Architectural Design Report - Response to Submission

# UNSW Health Translation Hub

This report has been prepared on behalf of UNSW as an addendum to SSD 10822510 for the Health Translation Hub building.

The report has been compiled to respond to the design-related submissions received by the Department of Planning and Environment and Randwick City Council during the public exhibition of the UNSW HTH.

## Item 35. Landscaping

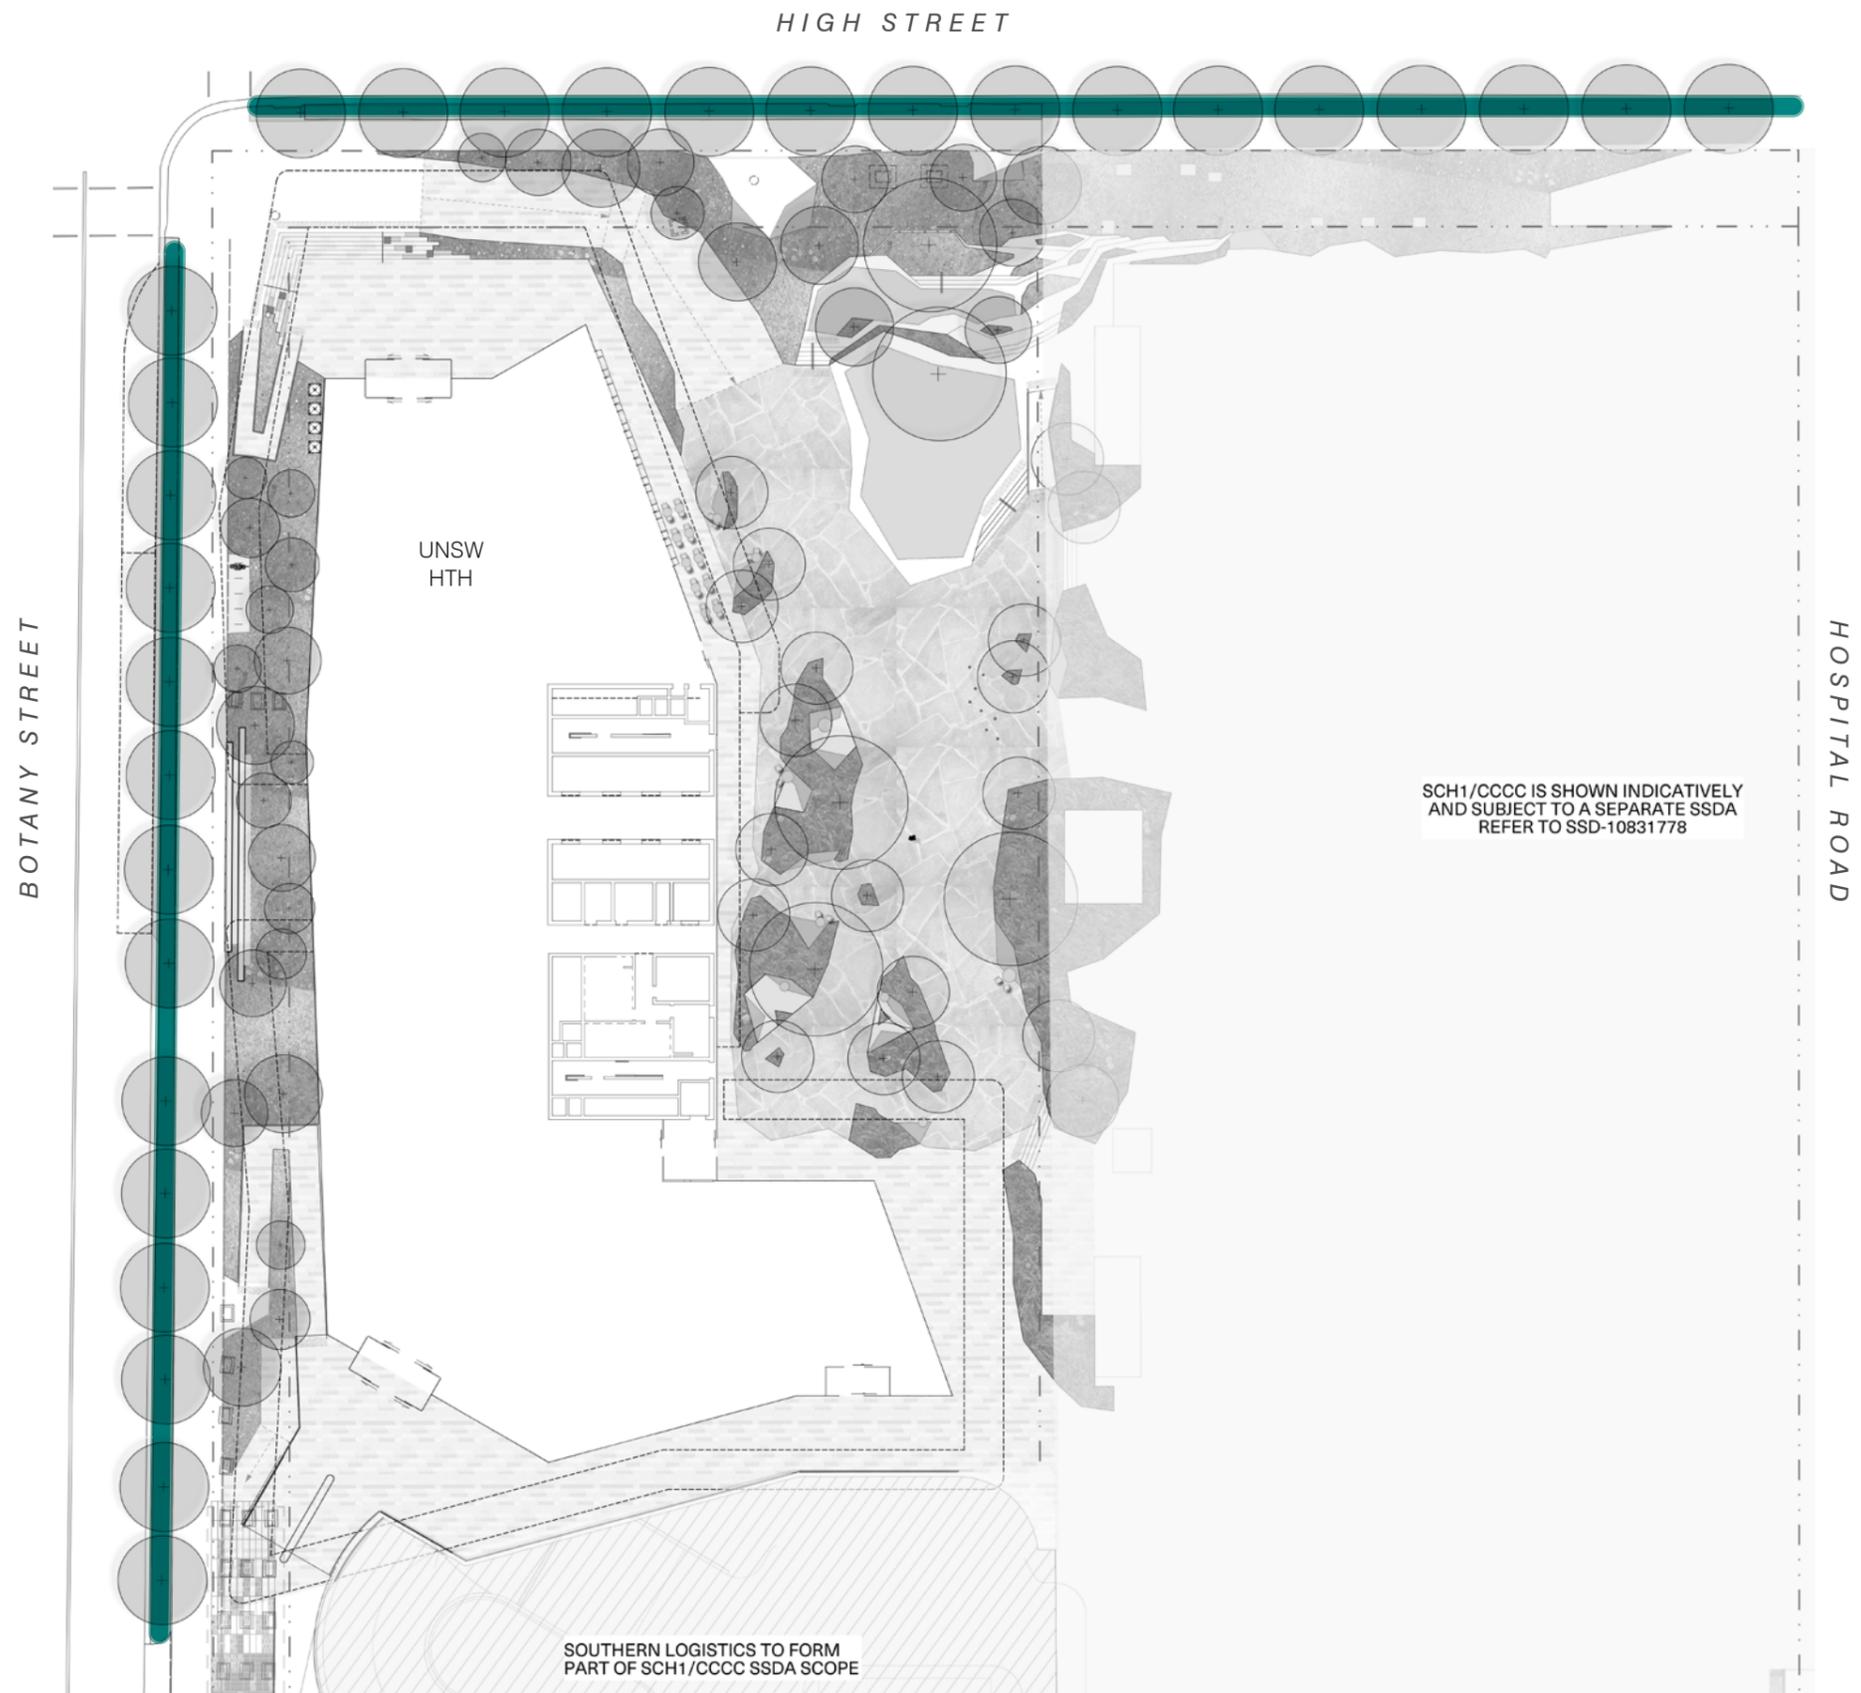
The indicative street trees and pavement level planting along the Botany Street and High Street frontages within Councils road reserve currently have a formal generic character. In contrast, the landscaping for the UNSW HTH site is inspired by the coastal dune system. A coordinated landscape outcome that picks up some of the sand dune planting themes along this section of the High Street streetscape would be beneficial. Council recommends coordination between Randwick City Council's public domain team and the proposals Landscape Architect moving forward.

The design team supports the recommendation to coordinate with Randwick City Council's public domain team moving forward.

We have included a preliminary endemic planting palette which can be implemented into the Botany Street and High Street frontages within Council road reserves. This will be further developed with ongoing collaboration with Randwick City Council.
